FORMER CENTRAL RETAIL PARK
ROCHDALE
DESIGN & ACCESS STATEMENT
ADDENDUM

ORRD-LRW-XX-XX-PP-A-00624_P03 | JULY 2024

This Design and Access Statement Addendum has been prepared by Leach Rhodes Walker for Wilmott Dixon and Rochdale Development Agency in support of the non material amendment to the currently consented residential development in Rochdale approval reference:22/01119/FUL.

4 Bed House Ground Floor Plan

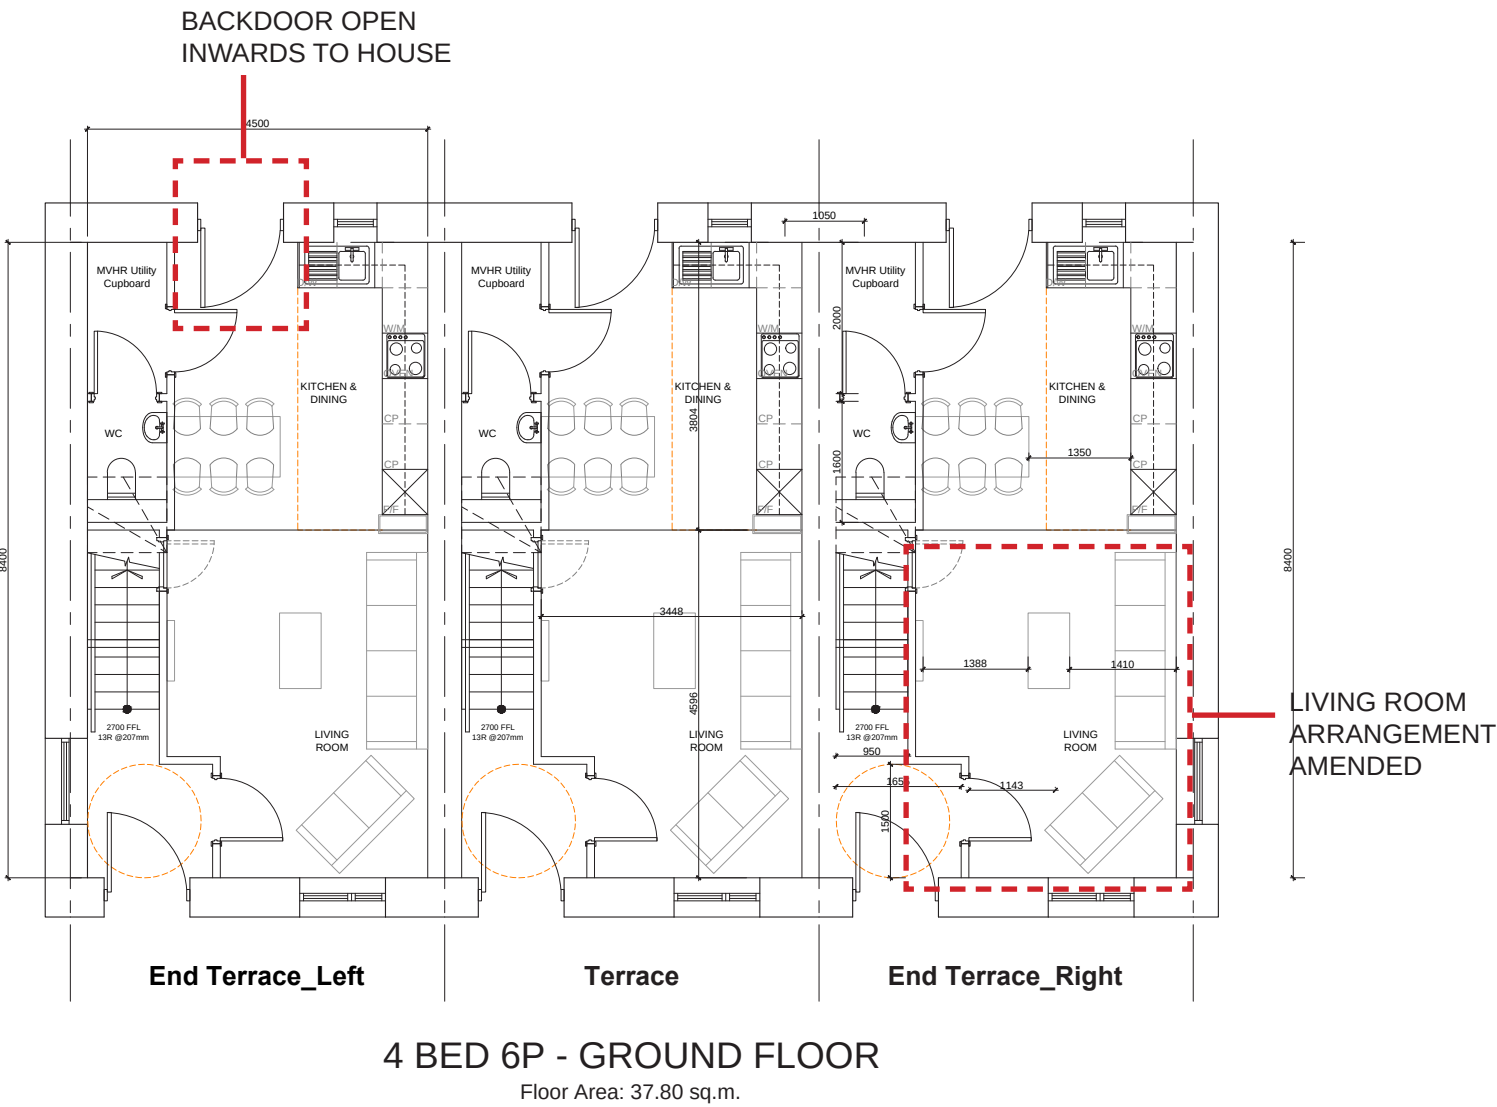
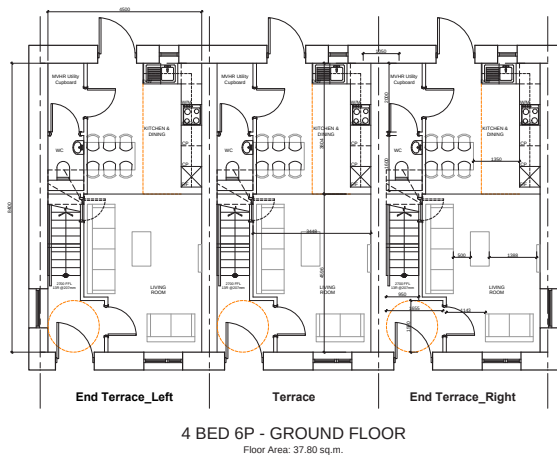
In the 4 bed handed house ground floor there are small amendments to the internal layout. This includes the backdoor which has been handed to open inwards. The living room layout has been handed to show the seating area along the exterior wall.

4 Bed House First Floor Plan

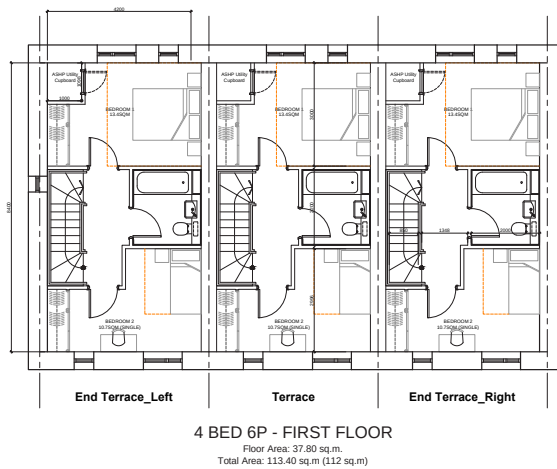
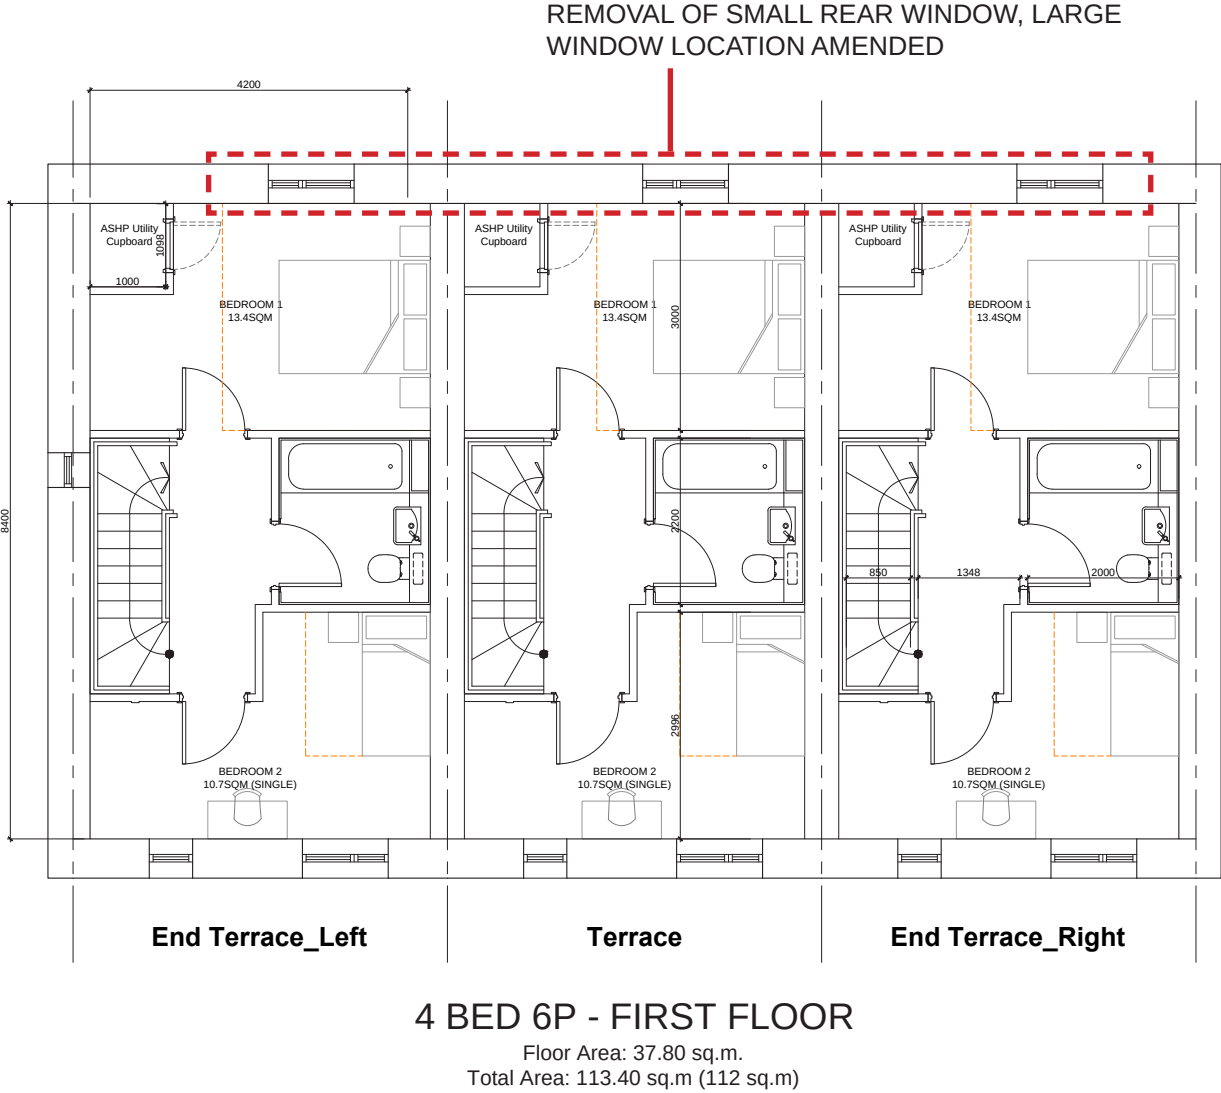
On the first floor of the 4 bed house the smaller of the two rear windows has been removed and as a result of this the larger window location has been amended to sit more centrally in the bedroom.

4 Bed House Second Floor Plan

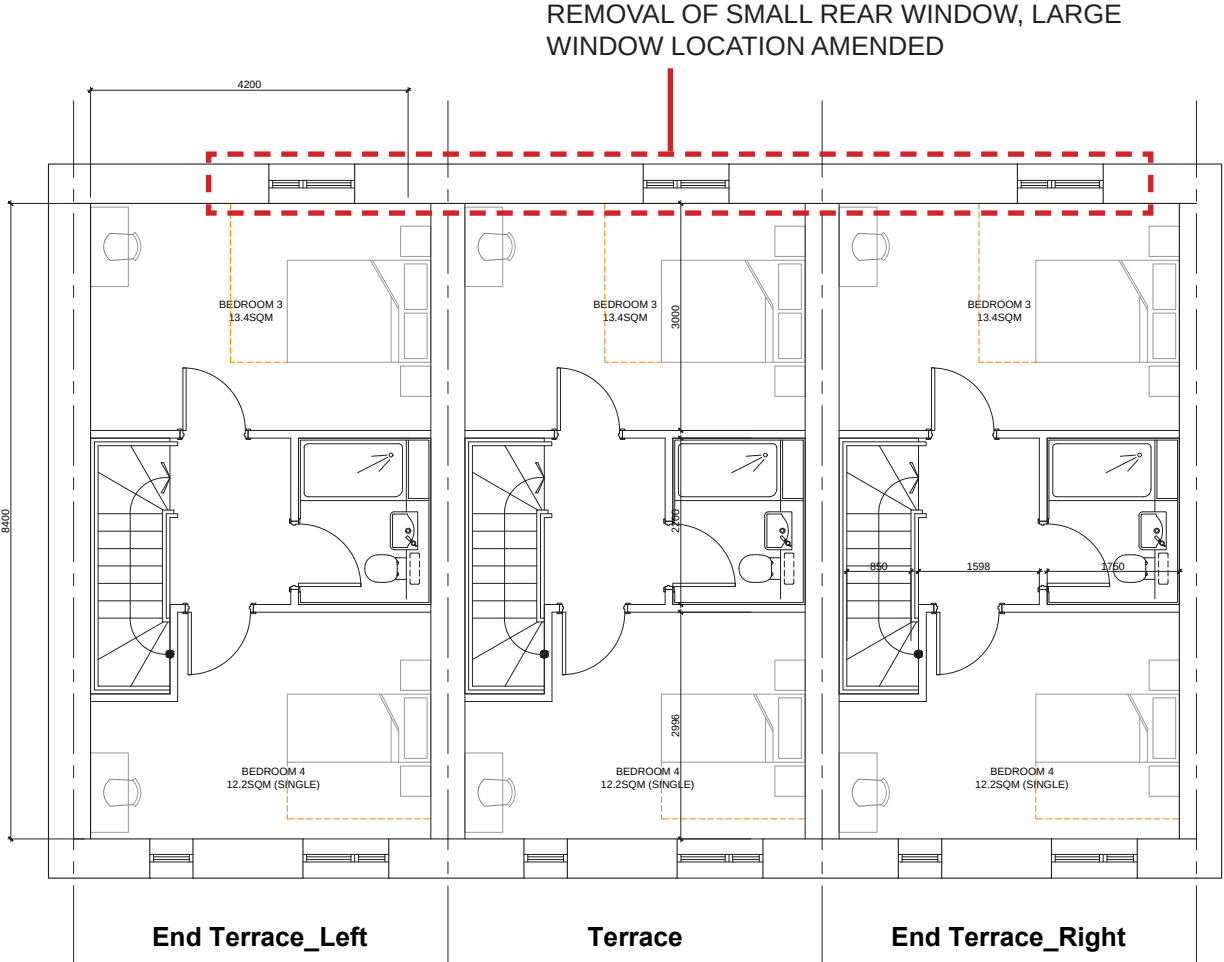
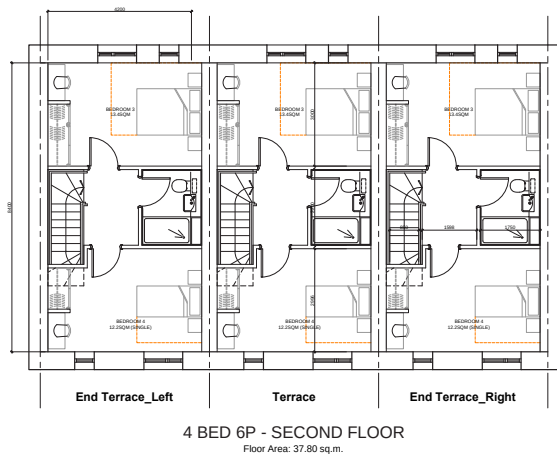
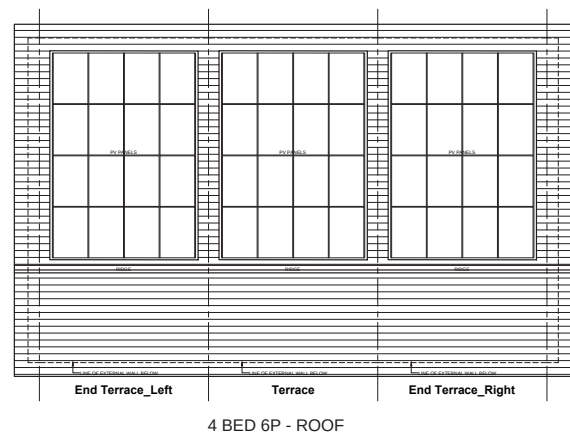
On the second floor of the 4 bed house the smaller of the two rear windows has been removed and as a result of this the larger window location has been amended to sit more centrally in the bedroom.

4 Bed House Roof Plan

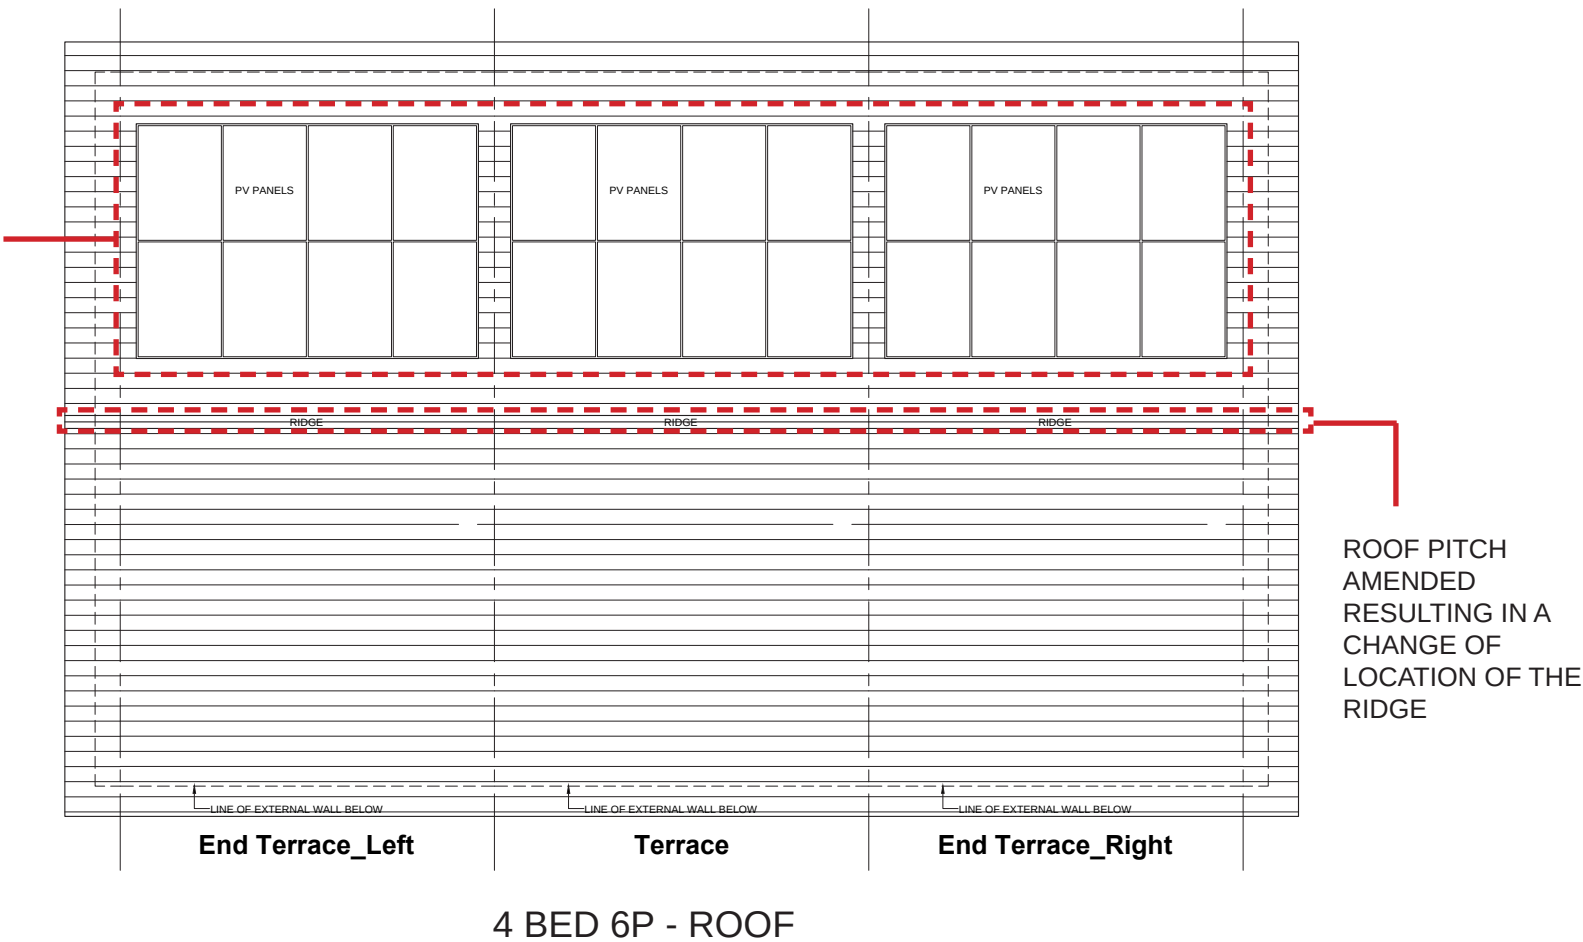
The roof plan of the 4 Bed house has been affected by the change of roof pitch resulting in the amendment of the ridge location and the reduction of 8 PV panels. The PV panels have also been adjusted in terms of size and location to suit the new roof pitch.

8 PV PANELS REMOVED TO SUIT NEW ROOF PITCH / SIZE & LAYOUT OF PANELS AMENDED (FINAL LAYOUT TBC)

4 Bed House Front and Side Elevation

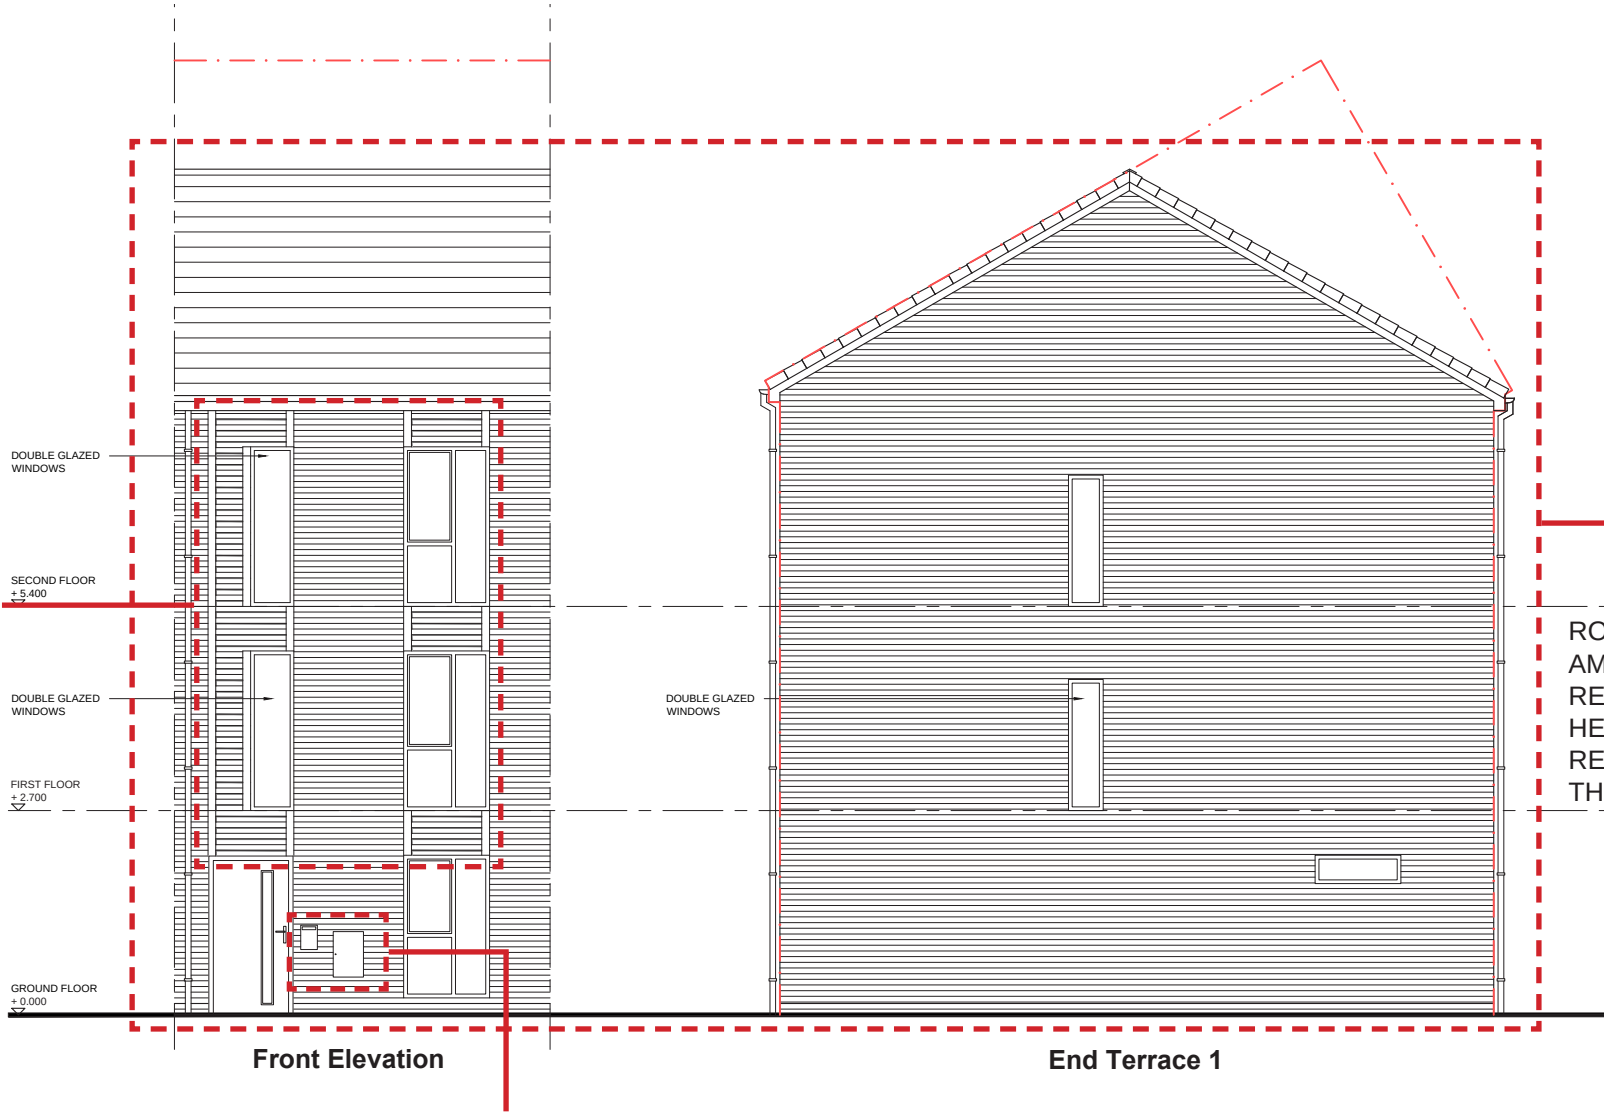
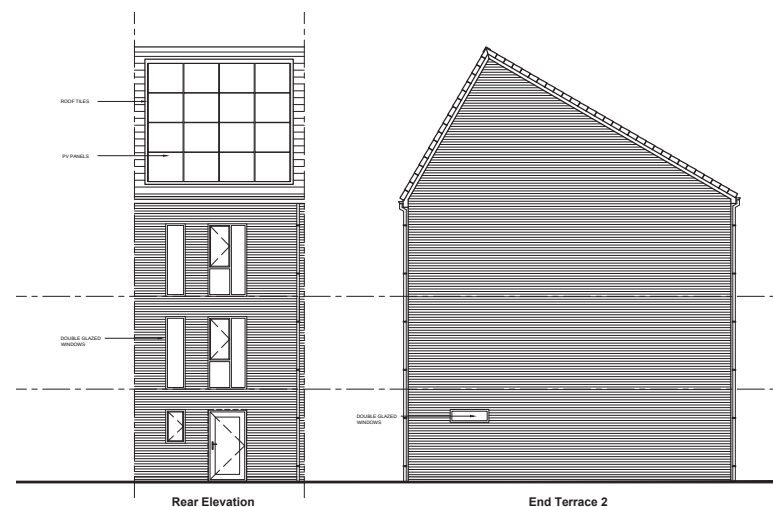
The 4 bed house front and side elevation have reduced in height due to the change in roof pitch. New brick detailing has been added to the front facade including feature brickwork with a 10mm recess every other course. Also, a postbox and meter box has been added to the front elevation.

ADDITION OF
NEW BRICK
DETAILING TO
FRONT
ELEVATION

ADDITION OF POSTBOX
AND METER BOX TO
FRONT OF HOUSE

ROOF PITCH
AMENDED
RESULTING IN A
HEIGHT
REDUCTION FOR
THE 2 BED HOUSE
